ORIGINATION FORM -

Proposed Revisions to a Standard Plans Index

Contact Information:	Standard Plans:
Date: June 5, 2023	Index Number: 455-440
Originator: Dino Jameson	Sheet Number (s): 1 of 4
Phone: (352) 955-2933	Index Title: Precast Concrete Sheet Pile Wall (CFRP/GFRP &
Email: dino.jameson@dot.state.fl.us	HSSS/GFRP)
Summary of the changes:

SHEET PILE DESIGN CRITERIA AND NOTES

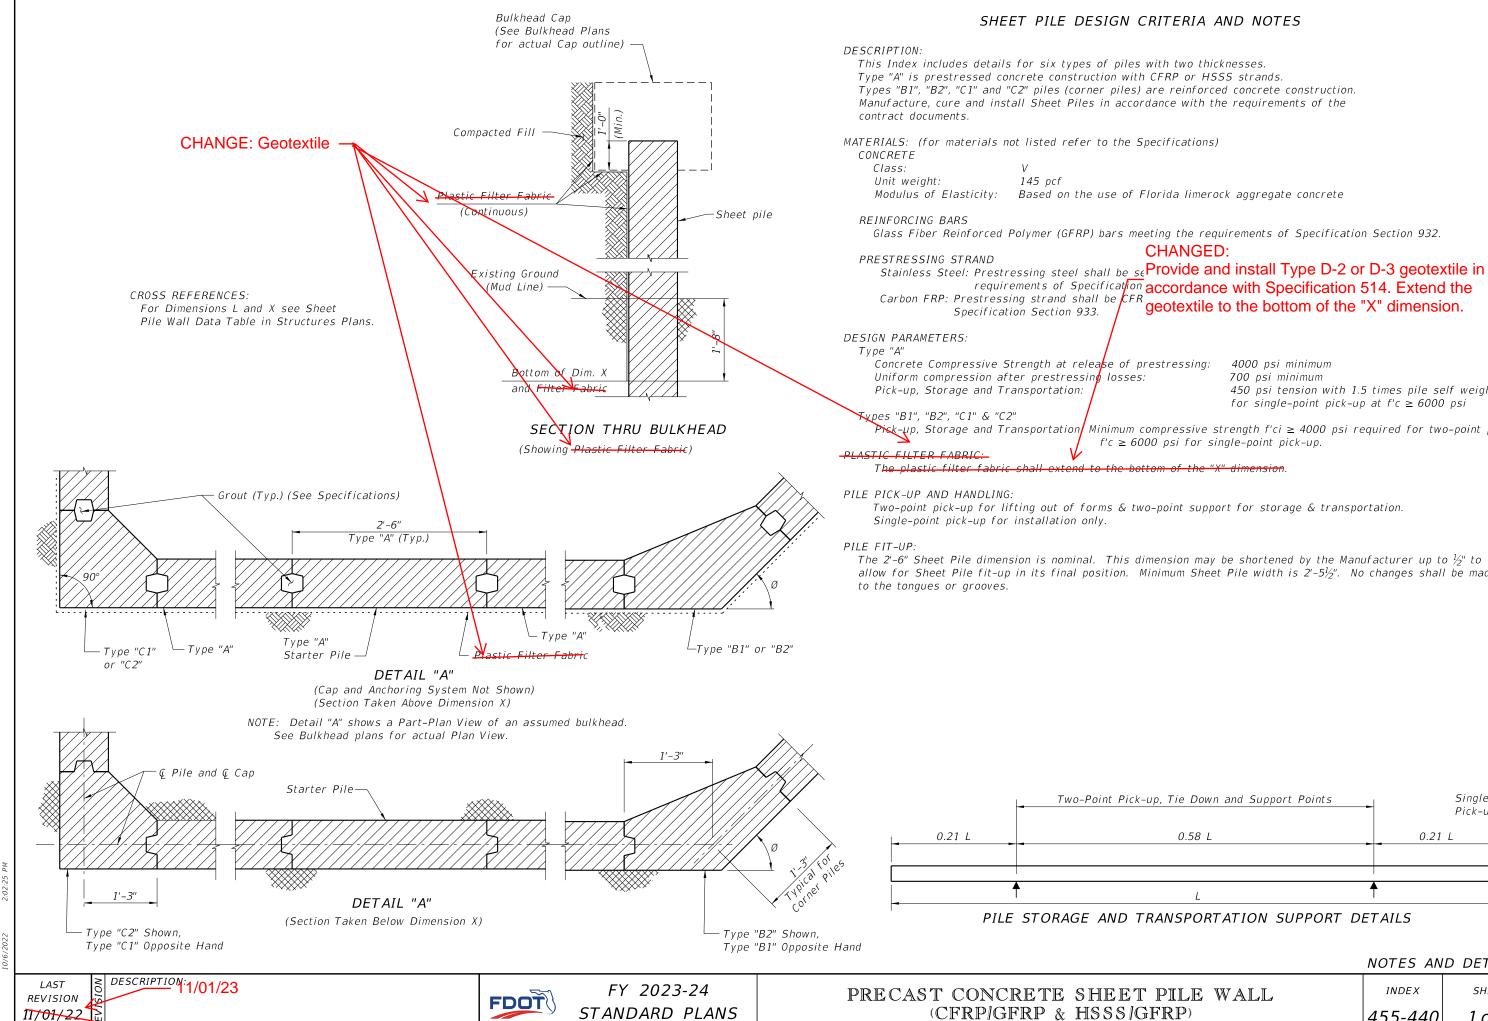
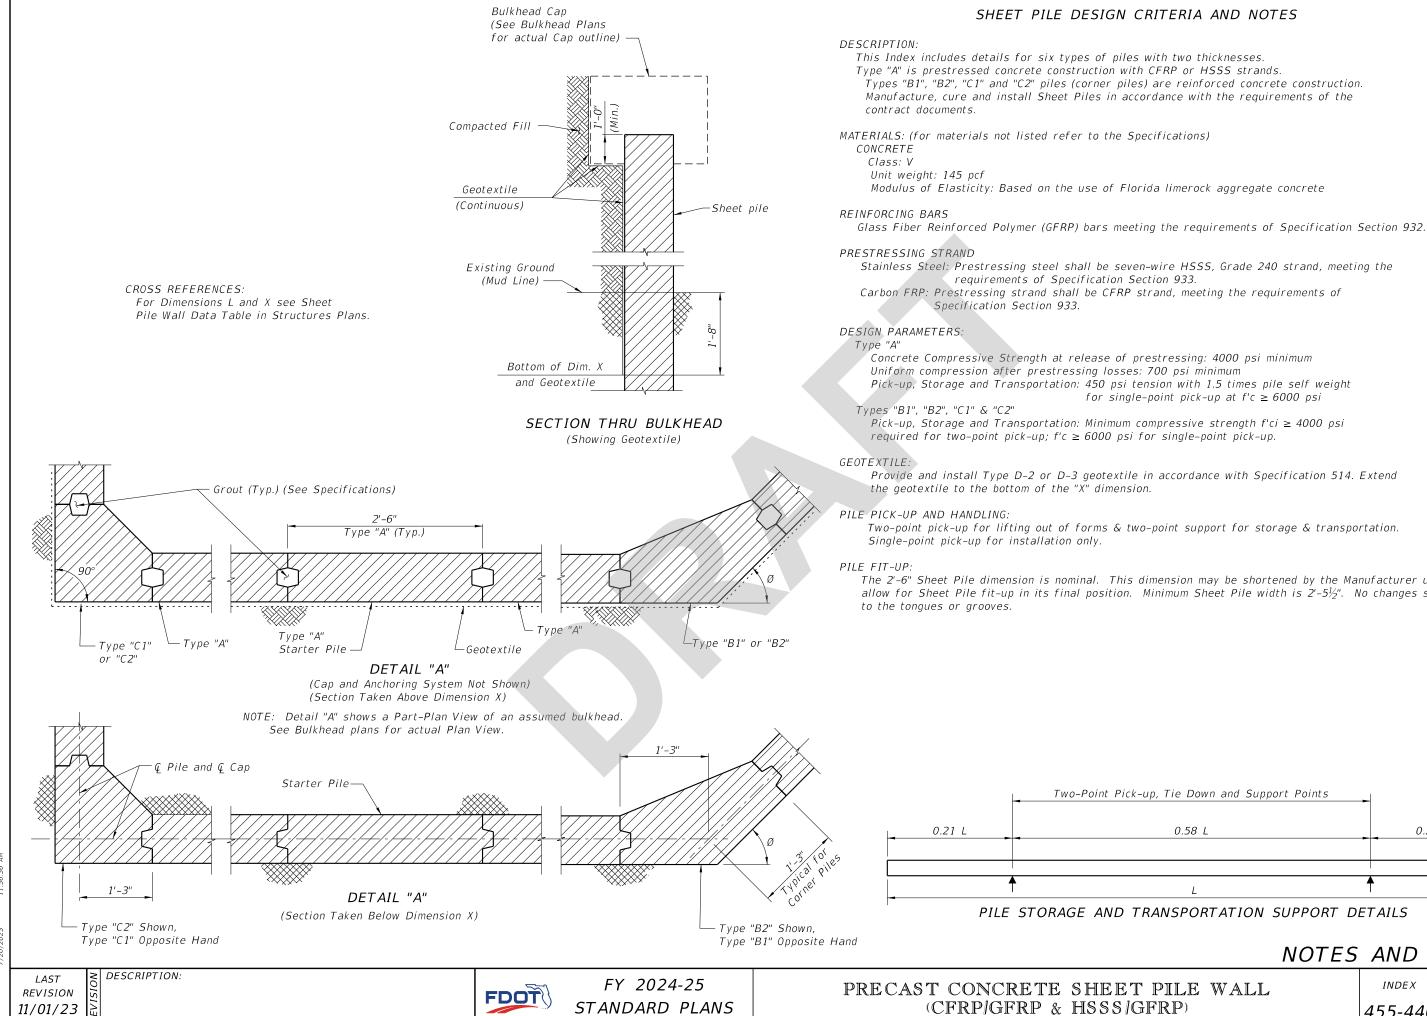
Sheet 1: Changed the "PLASTIC FILTER FRABRIC" Note in the SHEET PILE DESIGN CRITERIA AND NOTES to "GEOTEXTILE: Provide and install Type D-2 or D-3 geotextile in accordance with Specifications 514. Extend the geotextile to the bottom of the "X" dimension."; Changed all references of "Filter Fabric" or "Plastic Filter Fabric" to "Geotextile".

CHANGED:

Areas of the Standard Plans where 985 is referenced for drainage details needs to now reference Specs 514 (Division II specs). The Contractor is not responsible for the producer requirements division III specs, but ensure that the product used is on the APL and used for appropriate intended use. Specs 514 essentially does reference 985 to meet the materials requirement.
